**PLANNING BOARD REPORT
YARMOUTH, MAINE**

797 Princes Point Rd., Yarmouth, Maine
Shoreland Zone Permit

Prepared by: Nicholas Ciarimboli, Code Enforcement Officer

Report Date: February 28, 2023; Planning Board Meeting: March 8, 2023

Impervious Coverage (provided by the Applicant)

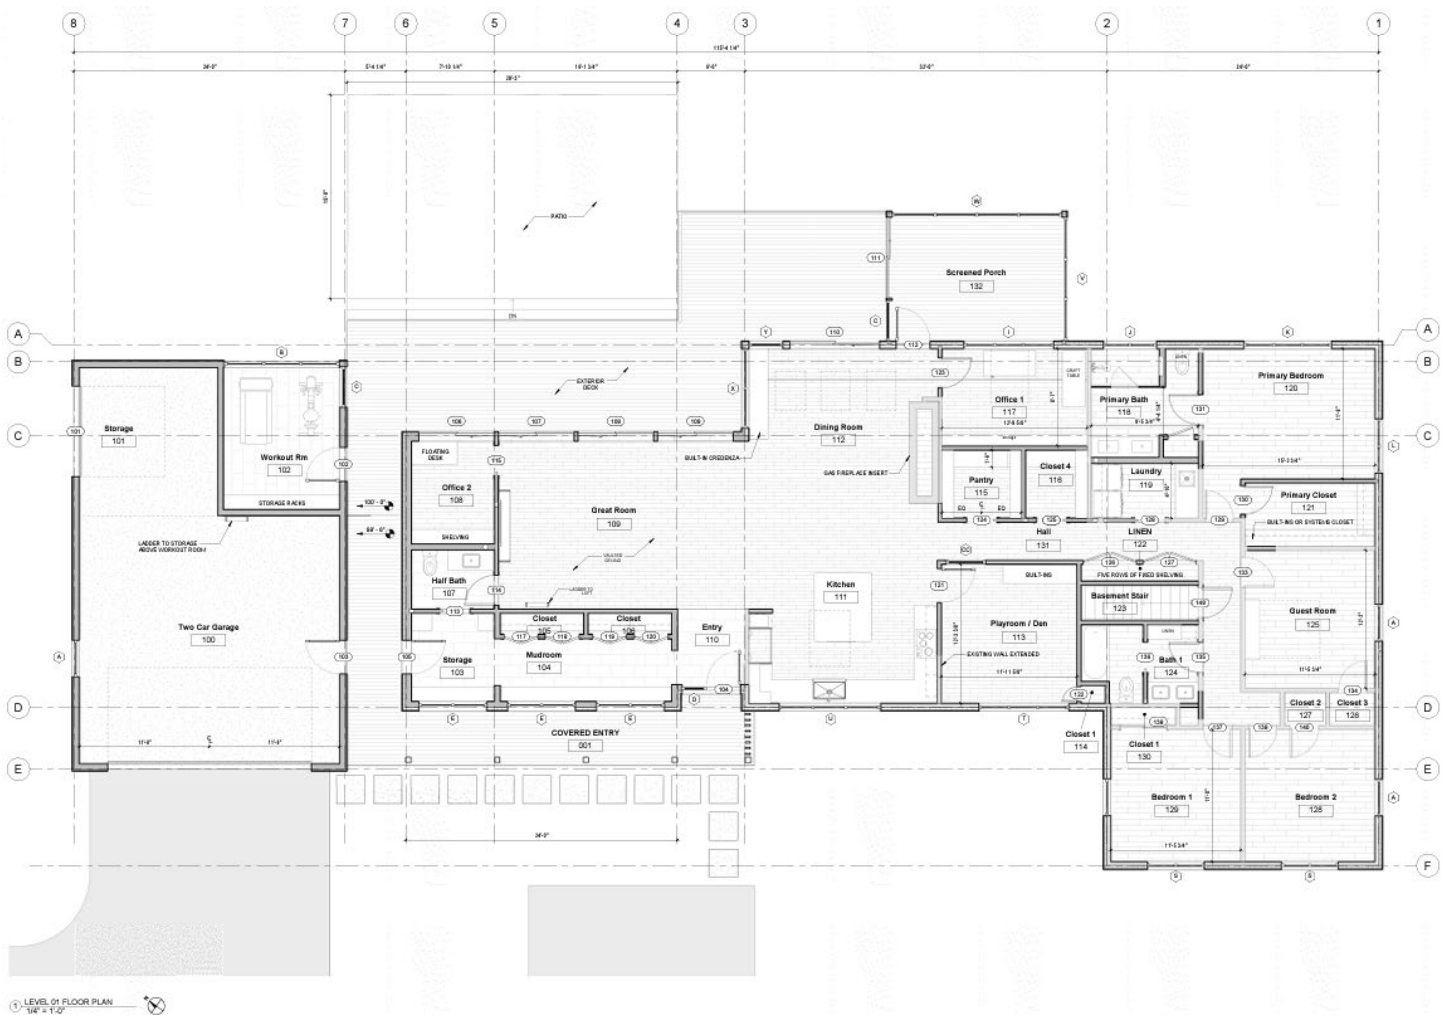
The lot complies with the lot coverage requirements, which is a maximum of 20 percent. The overall impervious area coverage increases from 8.42% to 10.99% including the house, new garage, walks, patios, and driveway.

Staff Comment: The entirety of the nonconforming portion is greater than 25' from the applicable benchmark. The proposed expansion of the nonconforming portion is limited the waterside patio and portion of the adjacent deck

area for a total expansion of 20.2% or 545 square feet. Maximum allowable expansion is 30%.
